UNITED STATES PATENT AND TRADEMARK OFFICE

Office Action Summary	Application No. 10/811,102	Applicant(s) WEIGERT ET AL.	
	Examiner Omar Rojas	Art Unit 2874

DETAILED ACTION

FIG. 1

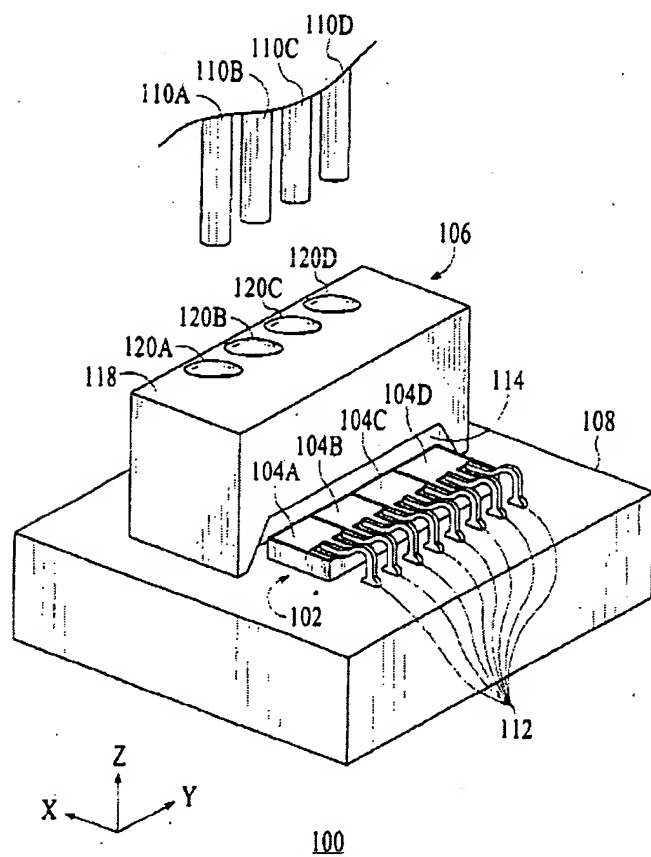
In re claims 1, 4, 8, 13, 14, 27, and 29, Wilson discloses an electrooptical module (100), comprising:

at least two electrooptical components (104A-104D) supported by a top surface of a common carrier (108) and operably coupled to an one optical waveguide (110A-110D), wherein:

the optical waveguide (110A-110D) is disposed above the top surface of the carrier (108);

the at least two electrooptical components (104A-104D) each are in an optical free-beam connection with the optical waveguide (110A-110D) by means of at least one lens (120A-120D);

an optical axis of emergent light from each of the least one lens (120A-120D) may converge so as to intersect an end of the optical waveguide at about the same point (column 4, lines 15-17);

wherein the at least two electrooptical components (104A-104D) comprises edge-emitting lasers arranged in a row (column 2, lines 60-62), the electro optical module (100) further comprising a supporting element (106) that has reflective coating (116, shown in Fig. 2) assigned to the laser or the lasers, the supporting element (106) and the reflectively coating (116) being arranged in such a way that they reflect the light emitted by the laser or by the lasers (104A-104D) about 90 degrees onto the respectively assigned lens (column 3; lines 29-36).

In re claim 2, the use of an "optical squint angle" for the lenses (120A-120D) is clearly suggested in Wilson's disclosure at column 4, lines 15-20 in view of Fig. 3. Furthermore, the waveguides (110A-110D) are arranged perpendicular to the top surface of carrier (108) as seen in Fig. 1.

In re claim 5, the lenses (120A-120D) are arranged on the supporting element (106) and located spatially above the electrooptical components (104A-104D) as seen in Fig. 1.

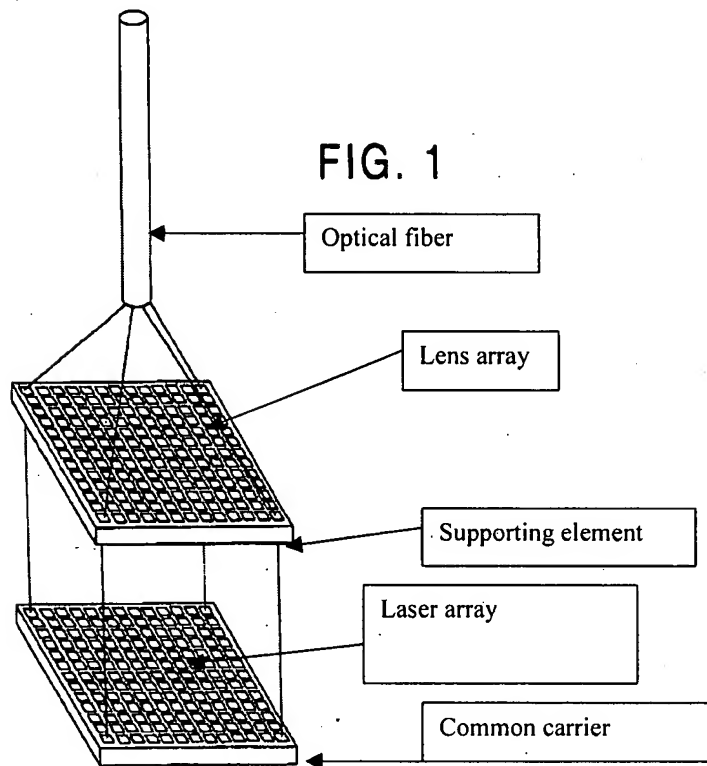
In re claims 1 and 8, Trezza discloses an electrooptical module (e.g., Figures 1-3), comprising:

at least two lasers supported by a common carrier and operably coupled to at least one optical fiber, wherein the optical fiber is disposed above the carrier;

the at least two lasers are in an optical free-beam connection with the optical fiber by means of at least one lens;

all the light from each of the lenses intersects the optical fiber at about the same point;
and

wherein the electrooptical module of Trezza inherently comprises a WDM module because it has the same physical structure to that claimed. A modified Figure 1 of Trezza is

reproduced below. Additional labeling has been provided to Figure 1 of Trezza to more clearly show the claimed features.

In re claims 2-5, 11-13, and 25, the recited limitations are clearly apparent from Trezza's disclosure at column 1, line 42 to column 2, line 21 in view of the modified Fig. 1 shown above.
